Document Update Notification

DOCUMENT NO: OP-1903.065

TITLE: EMERGENCY RESPONSE FACILITY
TECHNICAL SUPPORT CENTER (TSC)

CHANGE NO: 016-01-0

TECHNICAL SUPPORT CENTER

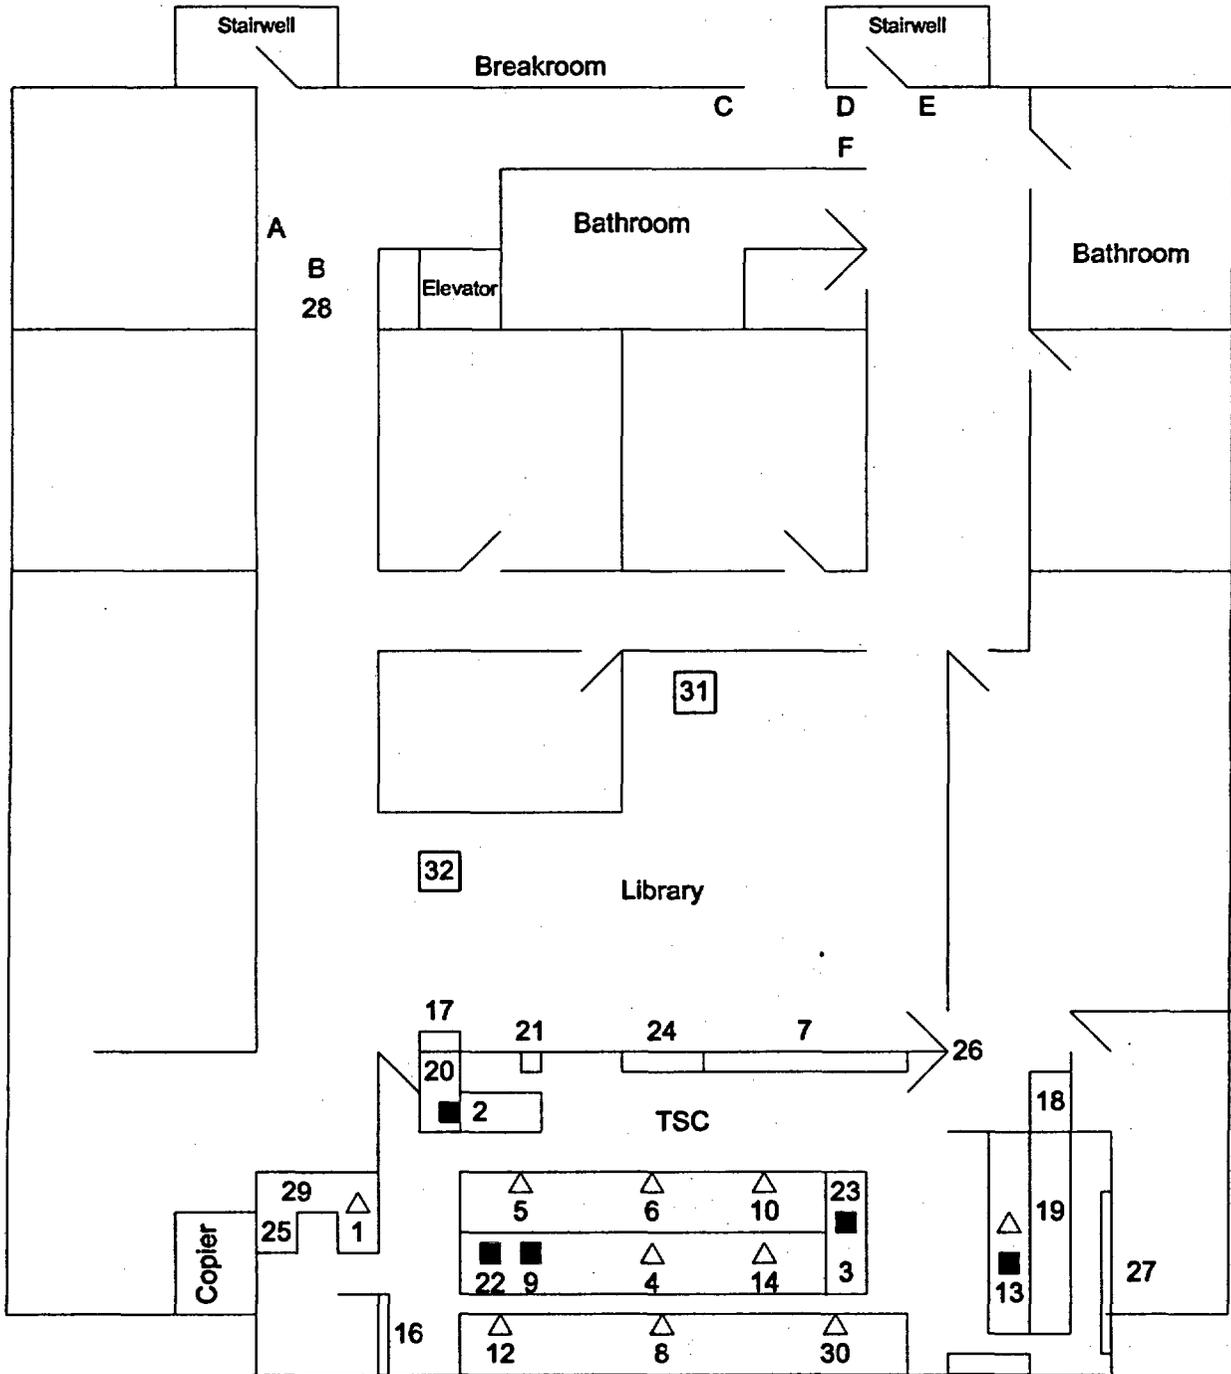
Moved CAM storage location (location 31) from closet near elevator to library area.
